Subject: Response to DEQ Comments on *Initial Stormwater Conveyance Mapping Results* from November 16, 2021

Project: Blue Heron Mill PPA
9-61M-135580.05

**Subject: Initial Stormwater Conveyance System Mapping Results – Revision 1
Former Blue Heron Property
419/427 Main Street
Oregon City, Oregon**

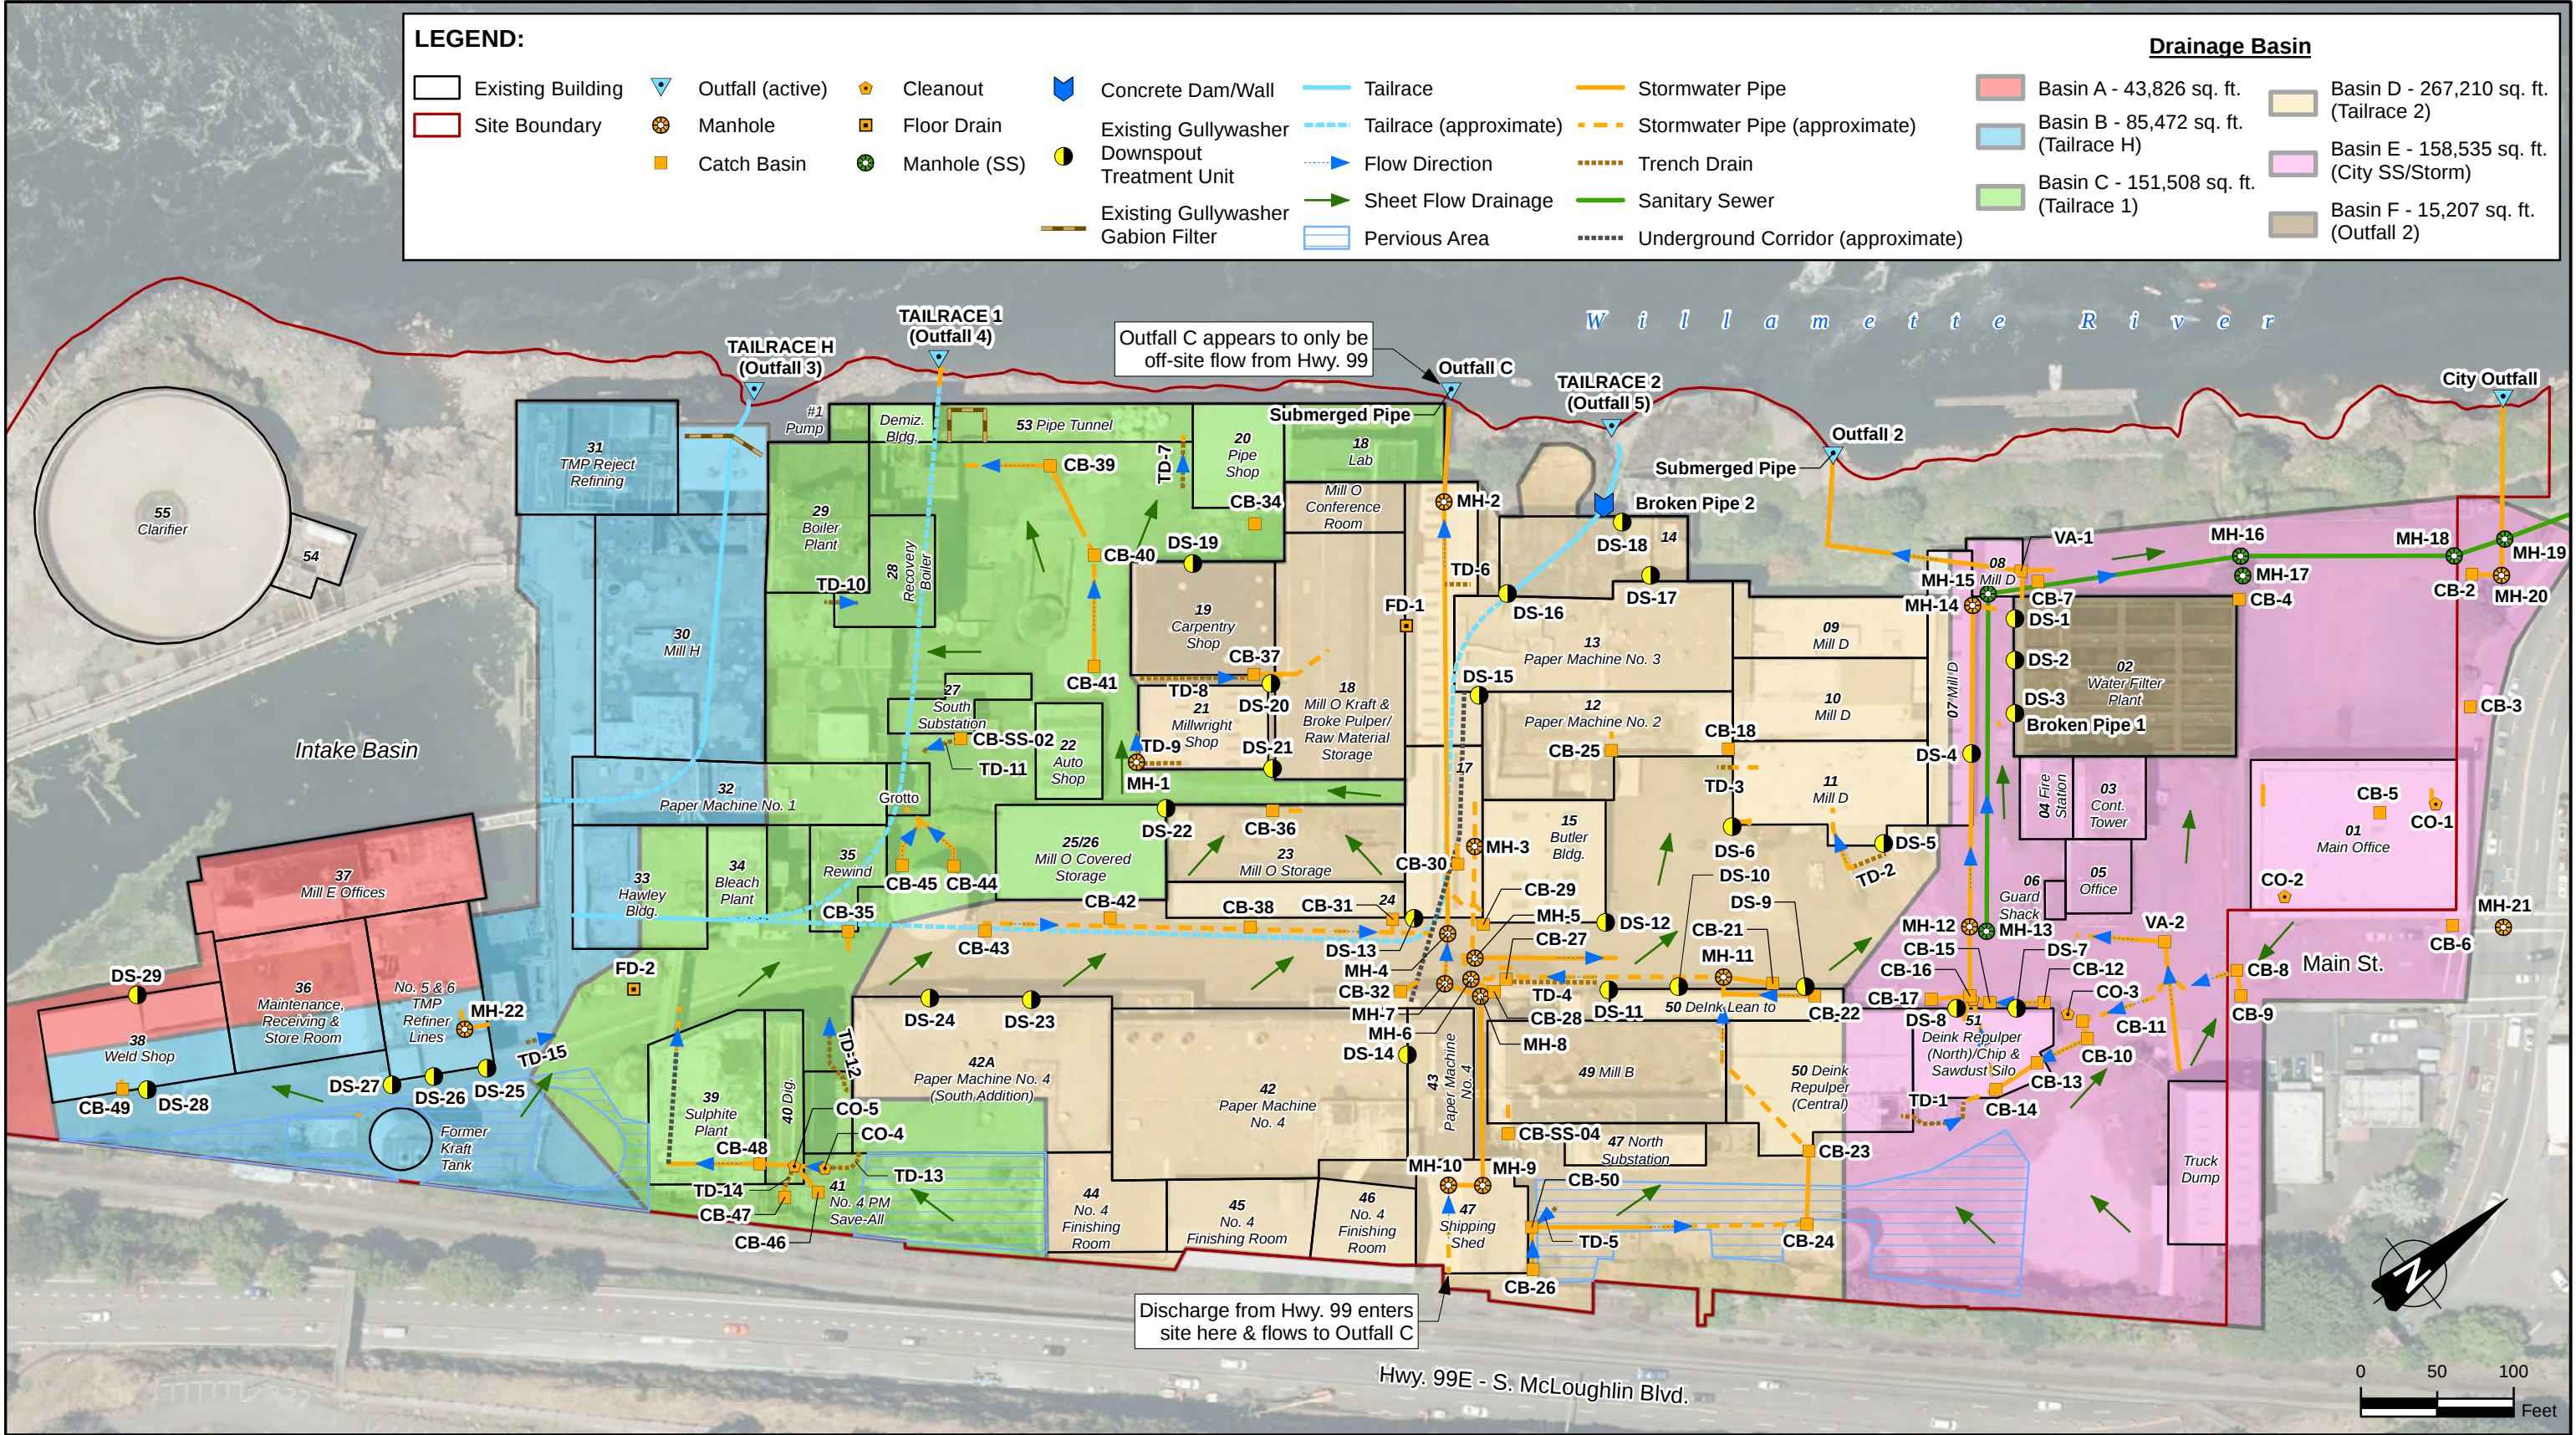
To facilitate identification, tracking and status of source control, please create a summary table that contains a unique identifier and pertinent information for each of the system features (e.g., trench drains, vault, sump, gully-washer, "broken pipe(s)"). Catch basins already have numerical designations and should be included on the table. The table should contain relevant information for each feature such as size, depth, drainage basin, and status of source control with respect to BMPs or cleanouts implemented, cleaning/scoping/sampling completed or pending/planned. The table will facilitate tracking and should be updated as appropriate, but at a minimum every quarter.

The report has been revised to include a stormwater conveyance system summary table and the figures have been revised to show unique identifiers for all stormwater features on the Site. The summary table is included in the report as Attachment C.

Figures 3A-3D – Drainage Basins (large scale version)

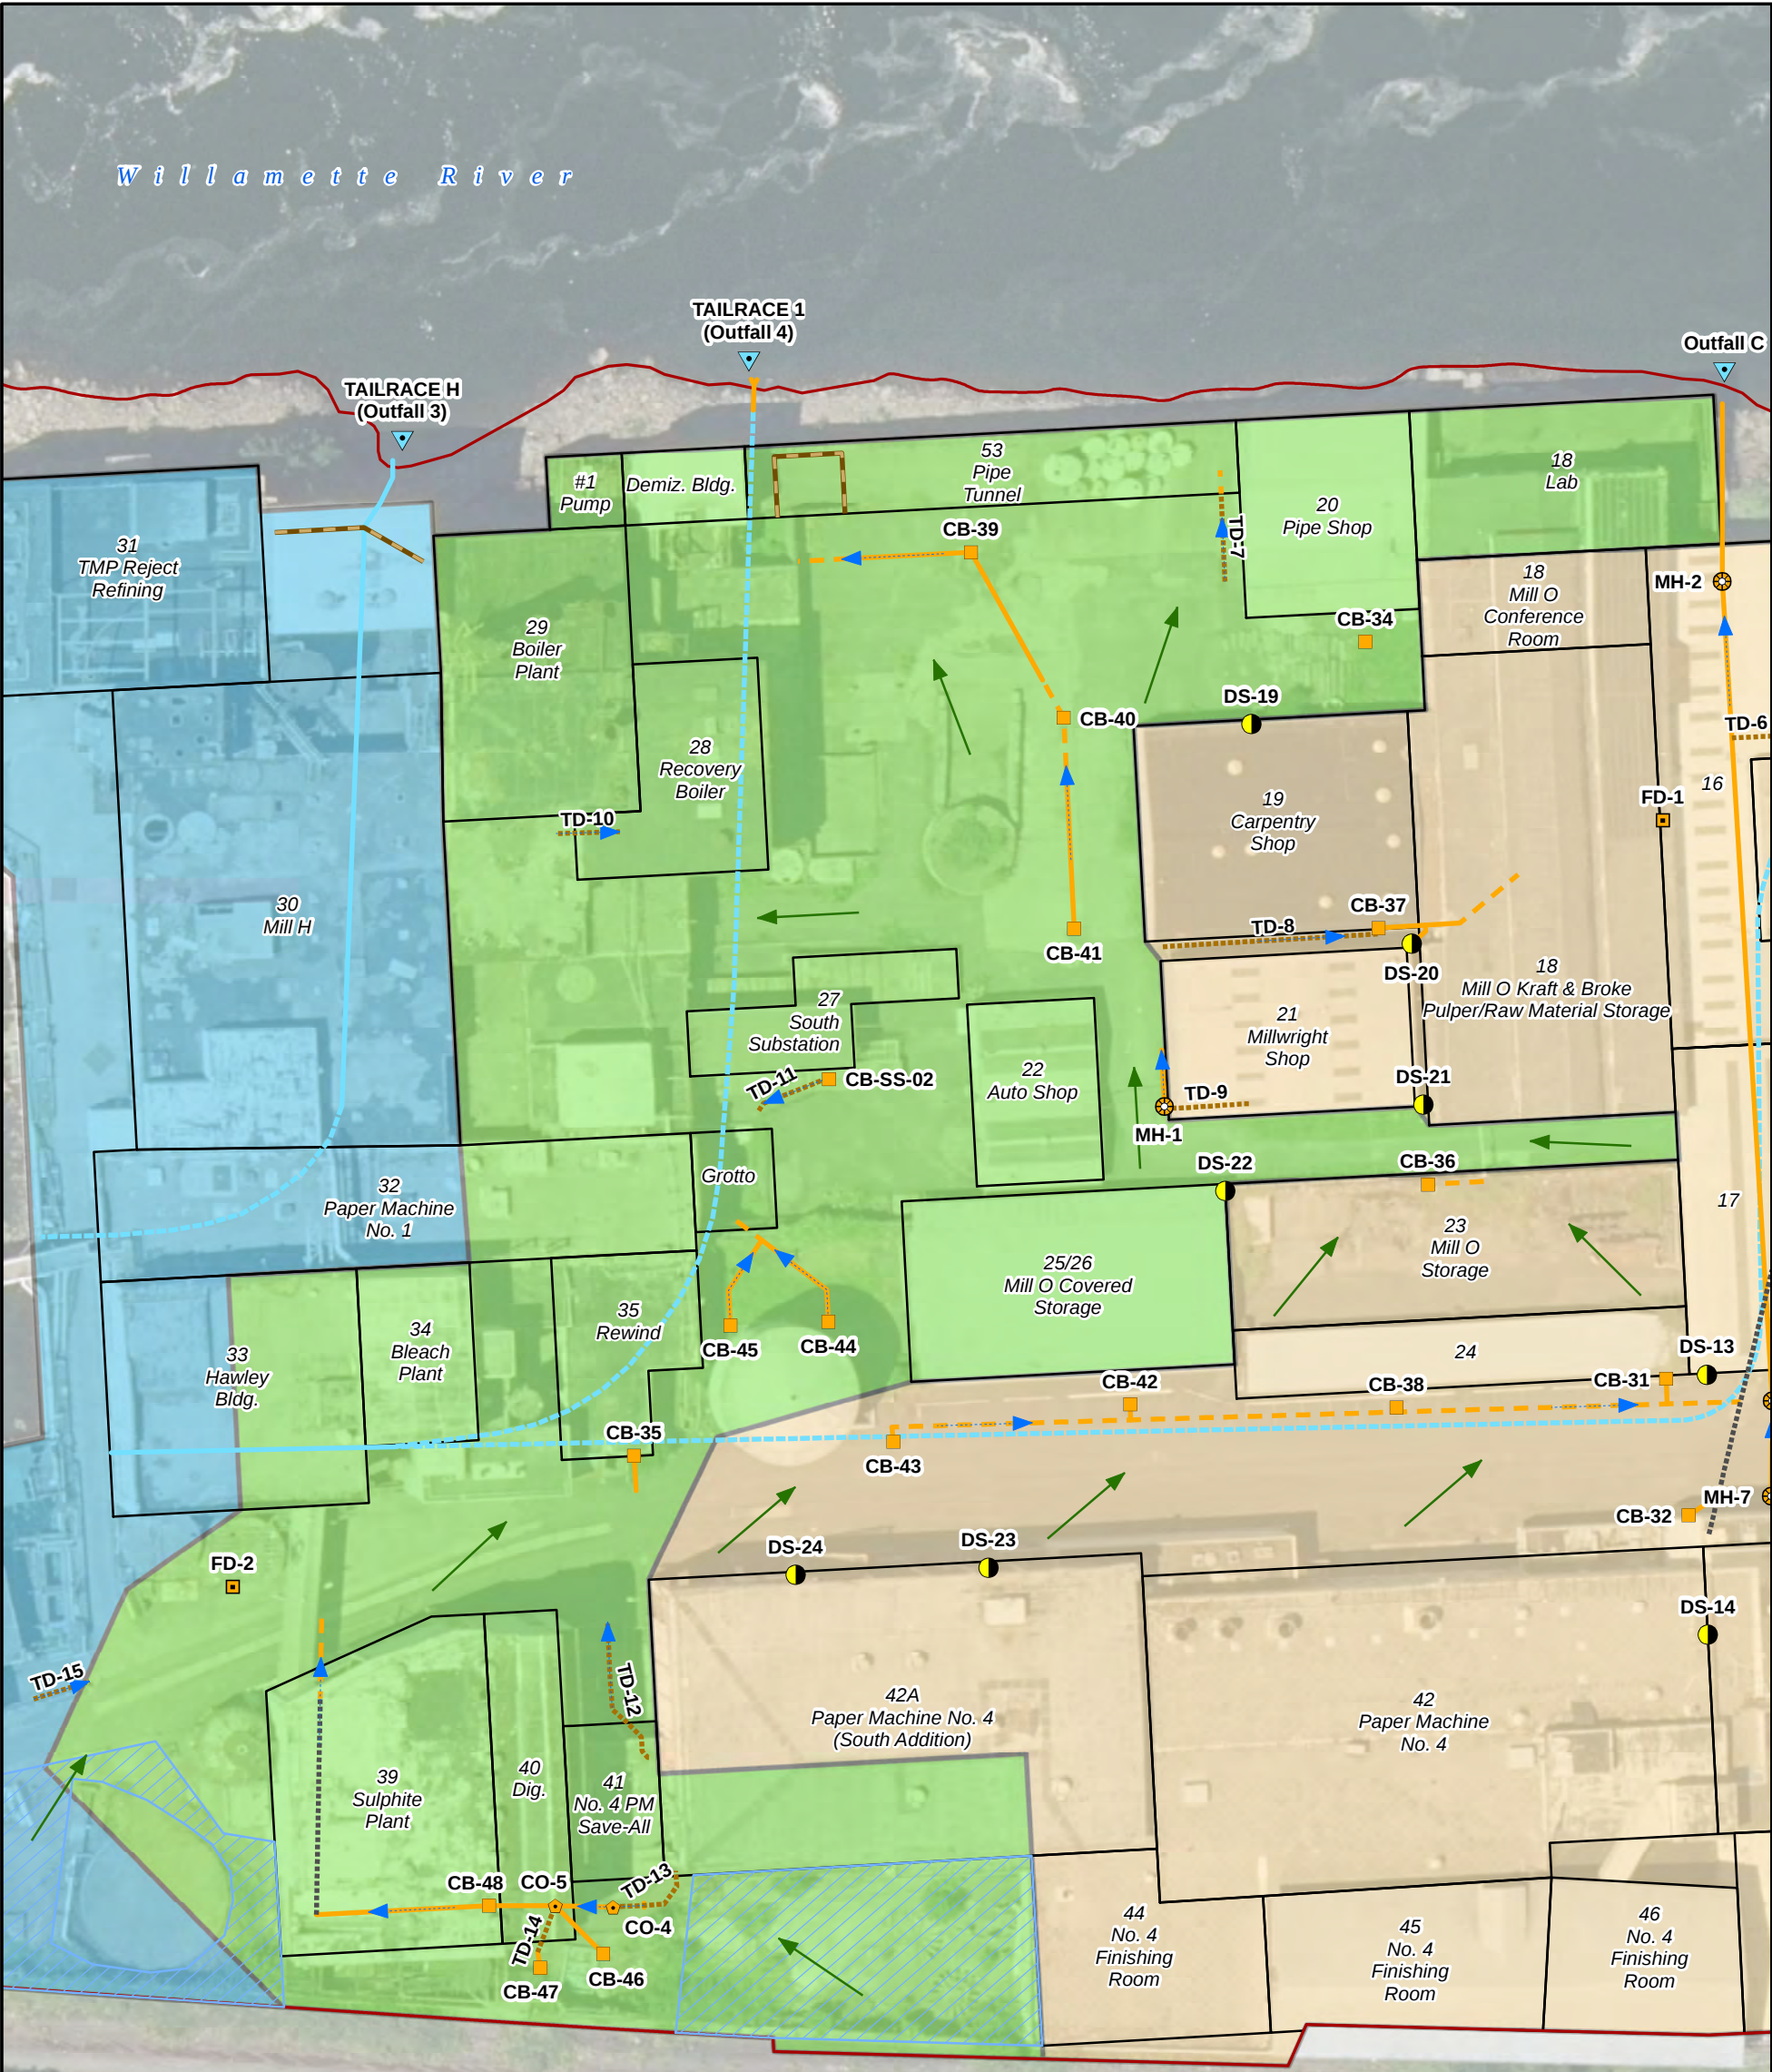
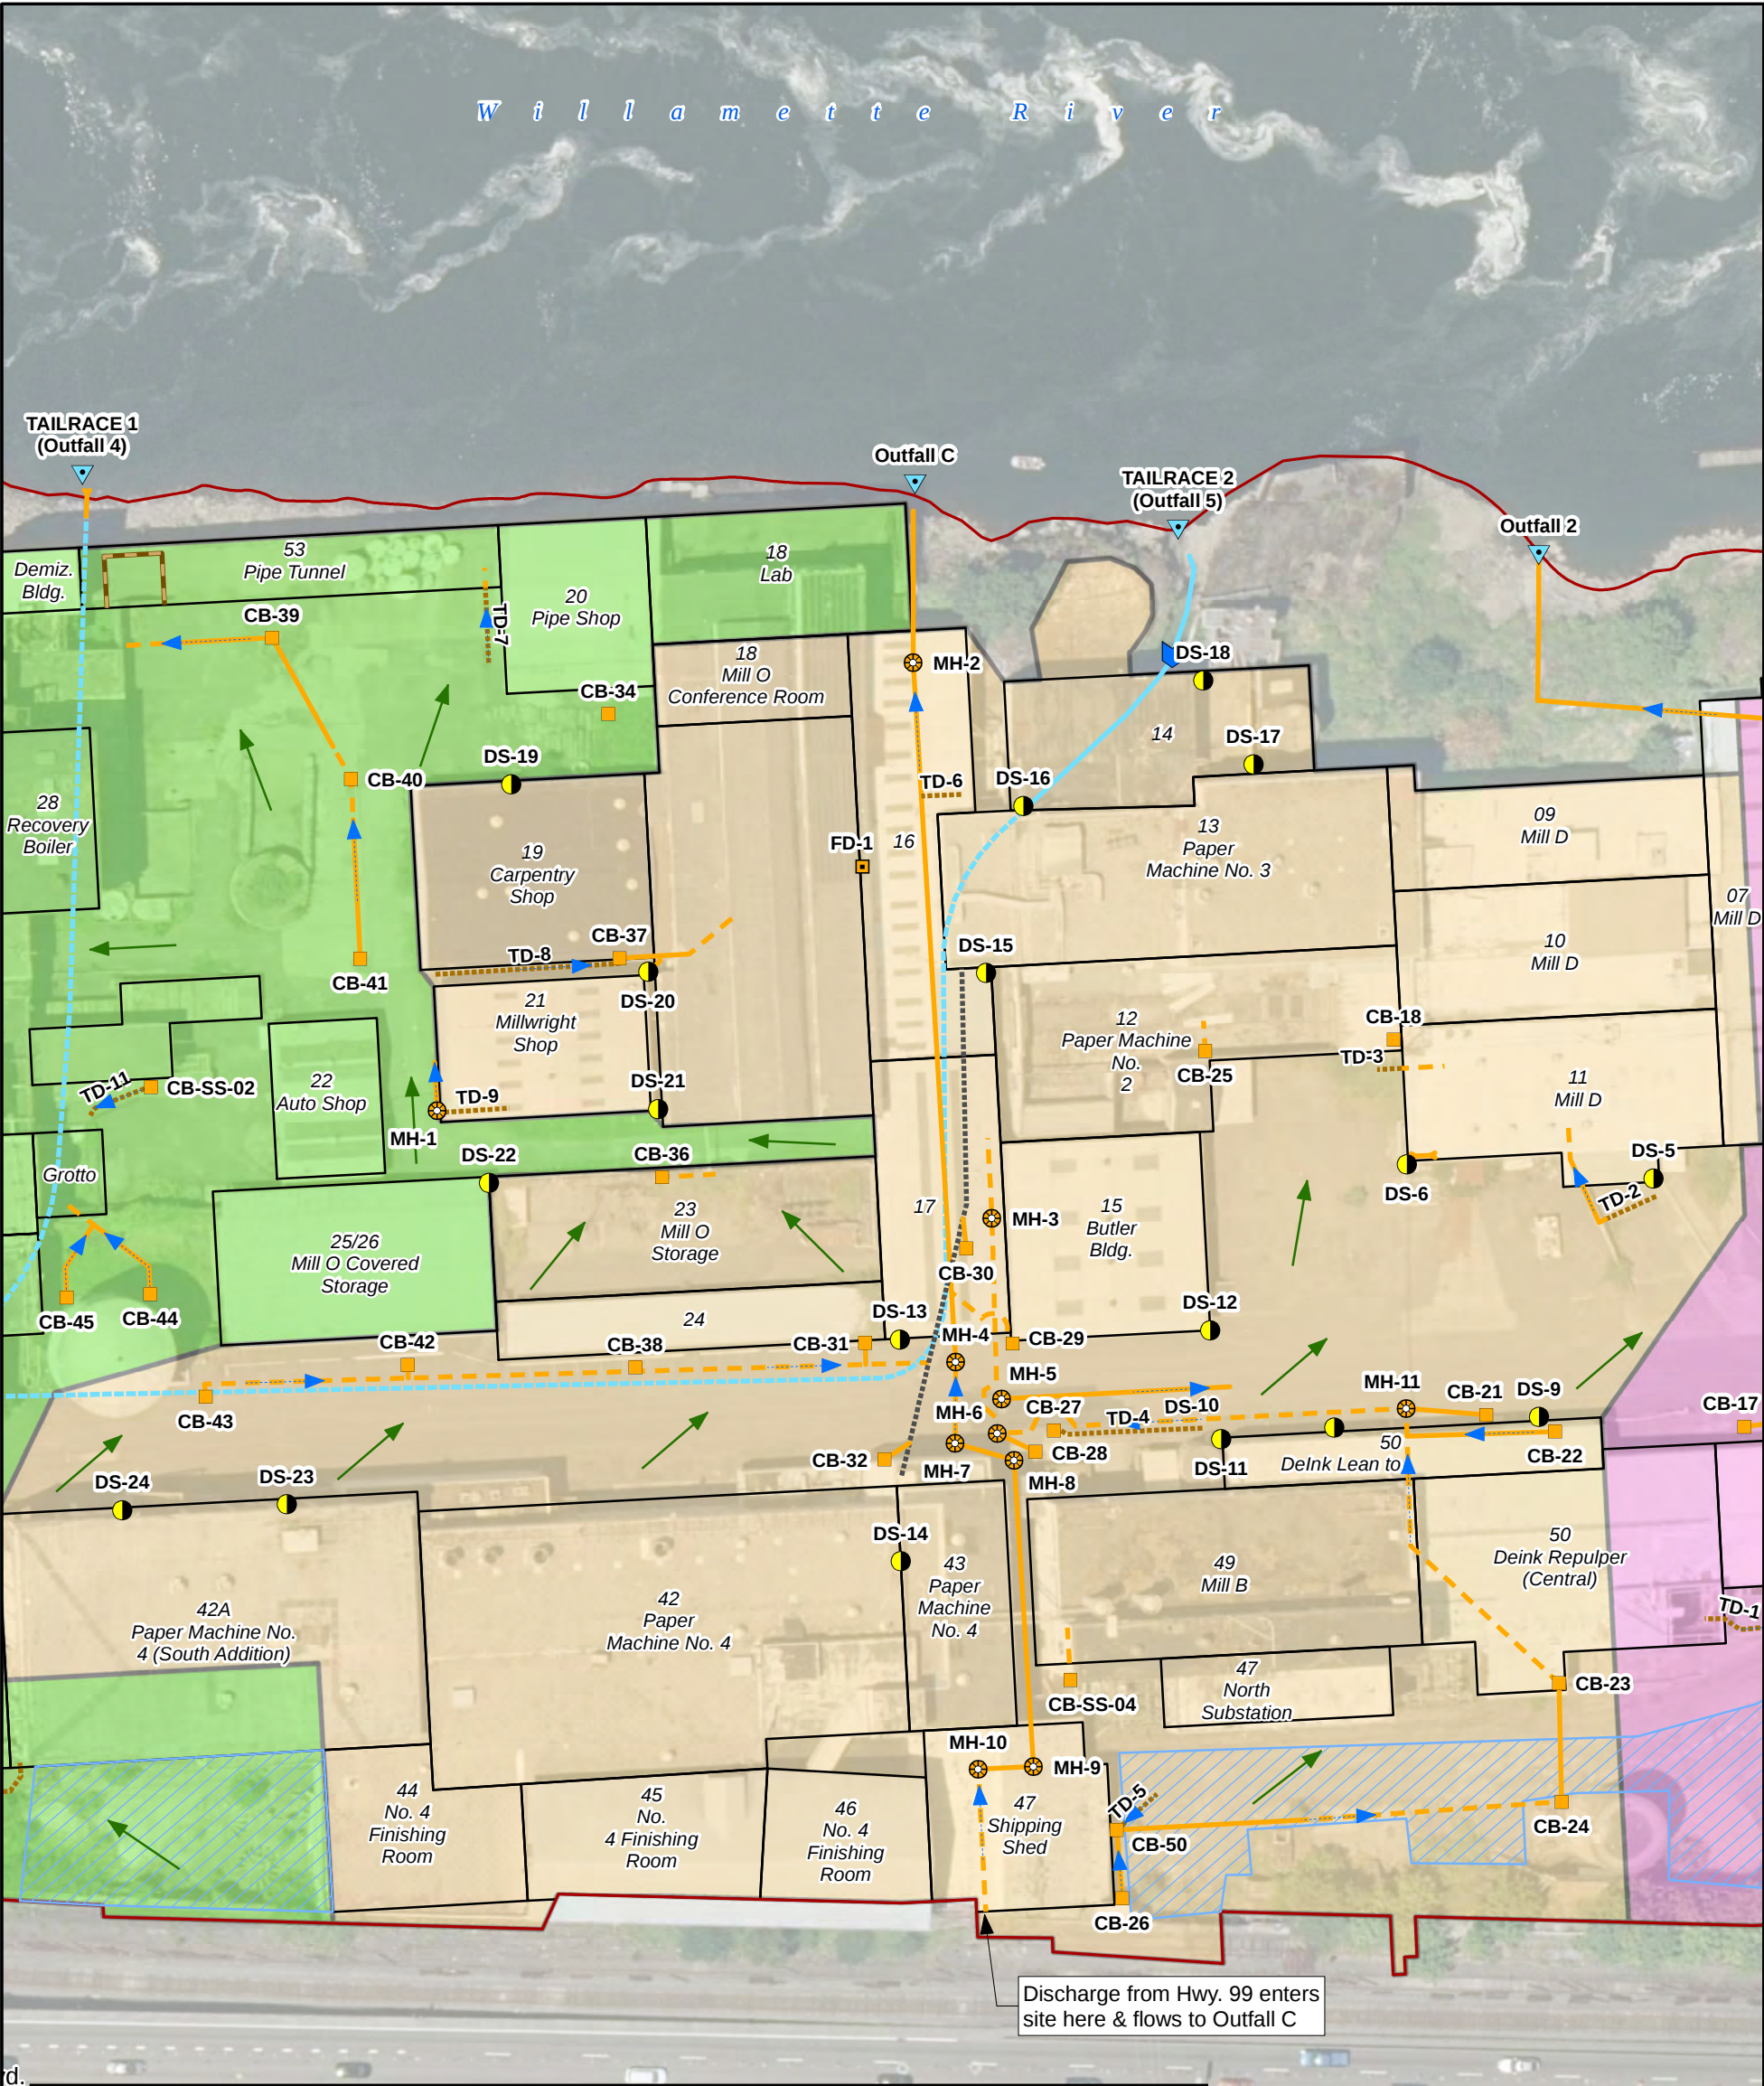
Please provide blown-up figures for each drainage basin to improve readability.

Large scale (blown-up) figures of each drainage basin are provided in Figures 3A-D.
